ADOPTION STATEMENT (January 2023) FOR DURHAM COUNTY COUNCIL LOCAL DEVELOPMENT DOCUMENTS

REVISED COUNTY DURHAM RESIDENTIAL AMENITY STANDARDS SUPPLEMENTARY PLANNING DOCUMENT (SPD)

CONSULTATION STATEMENT

Figure 1.0 – Overlooking from 2 and 3 story dwelling.

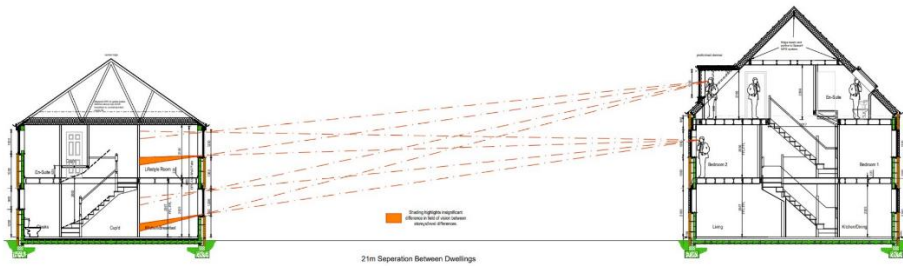
Persimmon Homes are concerned that the document provides no evidence in paragraph 3.3 to establish why there should be an additional 3m gap between buildings for every additional storey height. Is this figure from design research or is it an arbitrary distance? As shown in figure 1.0 below, there is very little difference in overlooking from 2 to 3 storey, so Persimmon Homes would like clarity as to why this additional distance is required.

In relation to separation distances, storey heights and site levels, the approach set down is intended to factor in potential impacts arising from specific site characteristics. The requirement to increase separation distances where there are measurable variations in site conditions is considered reasonable, given the related impacts these variations will have on aspects such as daylight penetration, privacy and ‘overbearing’. The figures set down in the SPD provide a straightforward, functional and consistent methodology. Nevertheless, the document allows for these requirements to be relaxed where the impacts on privacy can be reduced and to allow for variation on design grounds where sufficient, detailed information is provided to justify any relaxation. Each case would be judged on its merits in relation to these factors, however the starting point from the Councils point of view is ensuring that new development is well-designed and provides good amenity for existing and new residents.
